Re: Traffic Noise Response Letter
58 Florence Street, Ottawa
GWE File No.: 19-085 – Response Letter

This letter describes how we have addressed comments prepared by the City of Ottawa in their memo dated September 25, 2019 pertaining to the traffic noise assessment performed for the proposed residential-use development located at 58 Florence Street in Ottawa, Ontario. Below is a summary of how each of the comments relating to the noise study have been addressed. The number sequence below is in reference to each of the numbered comments continued in the memo.

Site

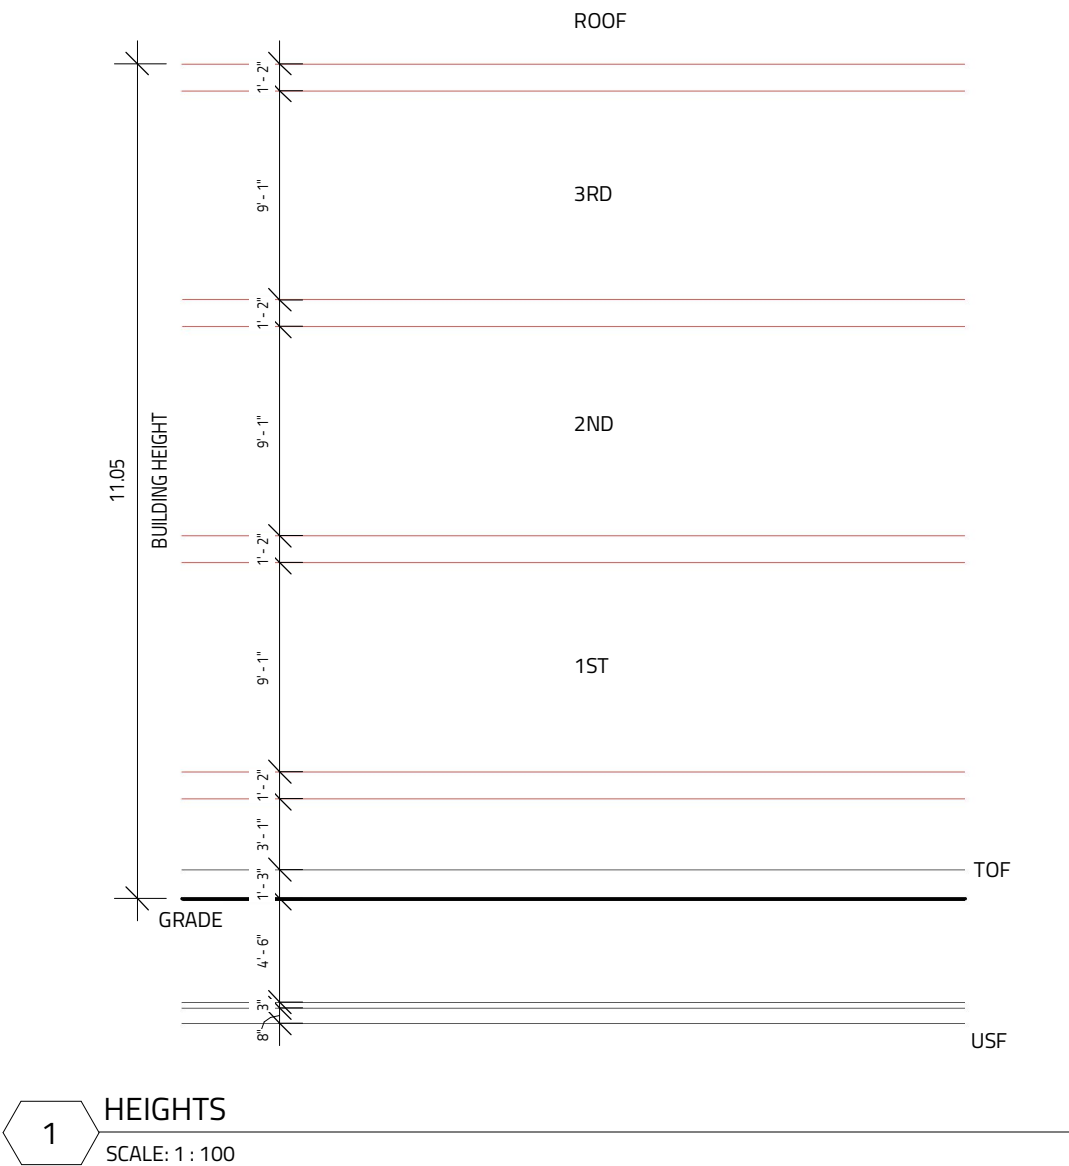
2. A copy of the site plan, elevation drawings and grading plan are to be included in the appendix as supporting documentation.

GWE Response: A copy of the site plan, elevation and grading plan drawings have been attached to this response letter. These documents are circulated at the time of submission and are made available on the City of Ottawa's development application website. Therefore, including them in our report is redundant.
